UNITED STATES PATENT AND TRADEMARK OFFICE

APPLICATION NO.	FILING DATE	FIRST NAMED INVENTOR	ATTORNEY DOCKET NO.	CONFIRMATION NO.
10/797,571	03/11/2004	Akihiro Moto	033035M143	4805

Office Action Summary	Application No.	Applicant(s)	
	10/797,571	MOTO, AKIHIRO	
	Examiner	Art Unit	
	Delma R. Flores Ruiz	2828

DETAILED ACTION

FIG. 11 (PRIOR ART)

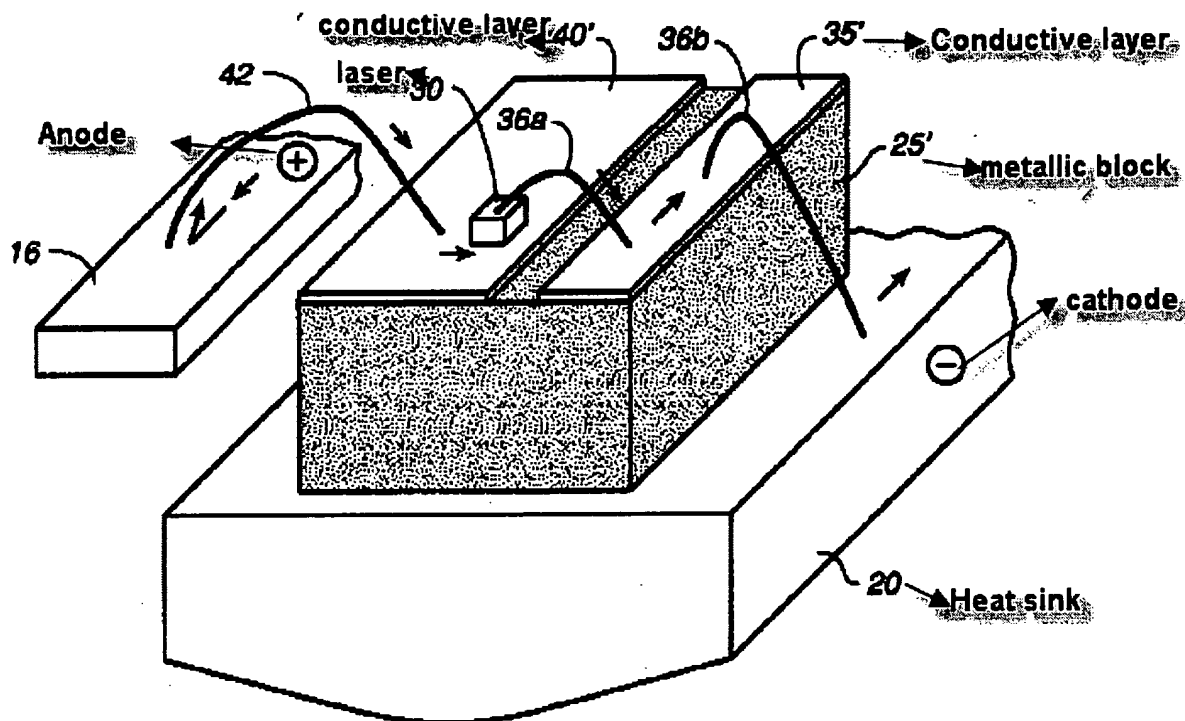
Regarding claim 1, Uchida discloses in Figure 11 and 12 a light-transmitting module, comprising: a stack of a metallic block (see Fig. 11, Character 25', Column 2, Lines 20 – 21), an insulating heat sink (21see Fig. 11, Character 20) mounted on said

metallic block and an electrically conductive layer (see Fig. 11, Characters 35' and 40') formed on said insulating heat sink, said stack forming a parallel-plate capacitor; and a laser diode (see Fig. 11, Character 30) having an anode and a cathode, said laser diode being mounted on said conductive layer such that said anode faces and is in contact with said conductive layer (Column 1, Lines 31 – 34, Column 2, Lines 11 – 41 and Column 3, Lines 1 – 10) .

Regarding claim 6, Uchida discloses in Figure 11 and 12 a light-transmitting module, comprising: a stack of an electrically conductive heat sink (see Fig. 11, Character 25', Column 2, Lines 20 – 21), an insulating layer provided on said heat sink (21see Fig. 11, Character 20) and an electrically conductive layer (see Fig. 11, Characters 35' and 40'), said stack forming a parallel-plate capacitor; and a laser diode (see Fig. 11, Character 30) mounted having an anode and a cathode, said laser diode being mounted on said conductive layer such that said anode faces and is in contact with said conductive layer (Column 1, Lines 31 – 34, Column 2, Lines 11 – 41 and Column 3, Lines 1 – 10)
